Alexander Schleicher
- Segelflugzeugbau -
Poppenhausen/Wasserk.

Modification No. 3
Glider K 7
US 7G3

LTA Nr 15

Changing of the middle elevator bearing support.

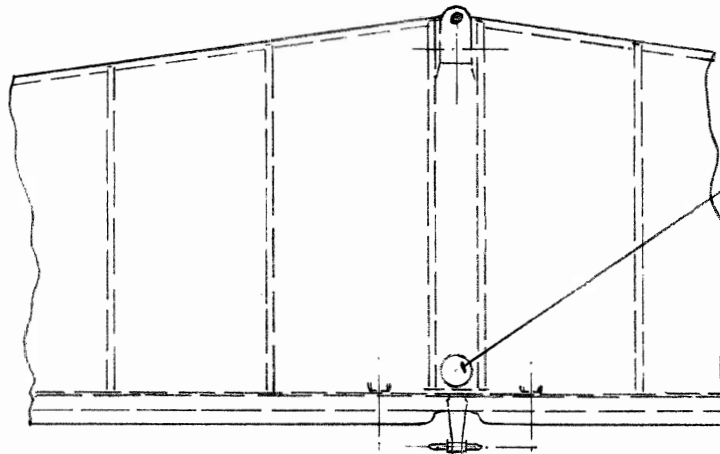
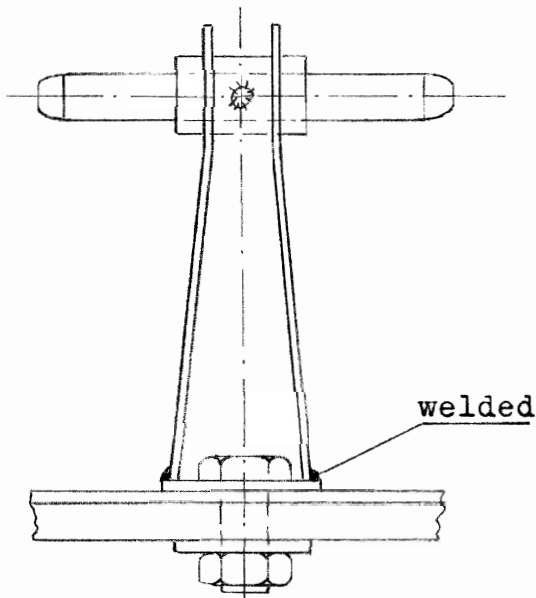
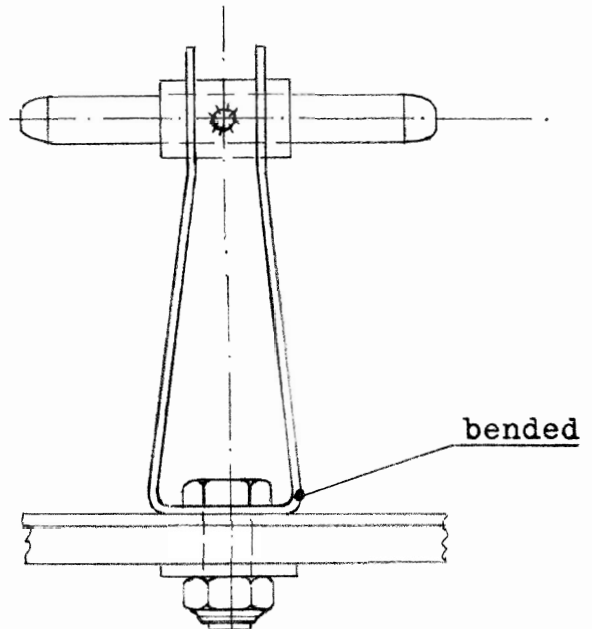
The bearing support of an aircraft cracked along the weld due to excessive grinding of the ground plate.

- 1.) Check the middle bearing support for cracks or grinded weld on the ground plate.
- 2.) Order a new bended support from the firm of Schleicher, Poppenhausen/Wasserkuppe, Germany
- 3.) Changing of the support see sheet Nb. 2

1. Cut in a hole into the plywood covering on the lower side.
4. Close later the hole with 0.04 " plywood.

2. Remove the old support.

3. Mount new support with new screws and nuts. Notice: No bearing thread, cut thread exactly.

Drawing L-211.38 - S 1
correct.
